Form 3160-3 FORM APPROVED OMB No. 1004-0137 (June 2015) Expires: January 31, 2018 **UNITED STATES** DEPARTMENT OF THE INTERIOR 5 Lease Serial No. NMNM102034 BUREAU OF LAND MANAGEMENT APPLICATION FOR PERMIT TO DRILL OR REENTER 6. If Indian, Allotee or Tribe Name 7. If Unit or CA Agreement, Name and No. **✓** DRILL REENTER 1a. Type of work: 1b. Type of Well: ✓ Oil Well Gas Well Other 8. Lease Name and Well No. 1c. Type of Completion: Hydraulic Fracturing ✓ Single Zone Multiple Zone BANJO 5 FED COM 771H 2. Name of Operator 9. API Well No. 30-015-54073 EOG RESOURCES INCORPORATED 3a. Address 3b. Phone No. (include area code) 10. Field and Pool, or Exploratory PURPLE SAGE;/WOLFCAMP (GAS) 1111 BAGBY SKY LOBBY 2, HOUSTON, TX 77002 (713) 651-7000 4. Location of Well (Report location clearly and in accordance with any State requirements.*) 11. Sec., T. R. M. or Blk. and Survey or Area SEC 5/T26S/R30E/NMP At surface NENE / 362 FNL / 417 FEL / LAT 32.078096 / LONG -103.896231 At proposed prod. zone SESE / 230 FSL / 330 FEL / LAT 32.050503 / LONG -103.895948 12. County or Parish 14. Distance in miles and direction from nearest town or post office* 13 State **EDDY** NM 15. Distance from proposed

Proposed Wellbore Design A

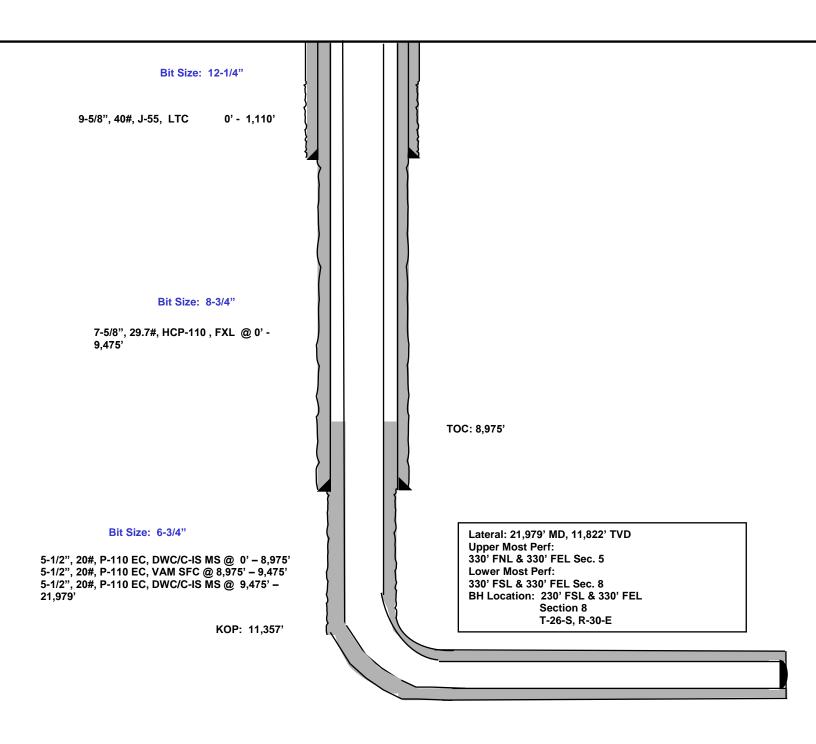
Operator is only approved for Design A. Design B is not to be utilized. If Design B is needed or any other change, please submit a NOI sundry to make the changes.
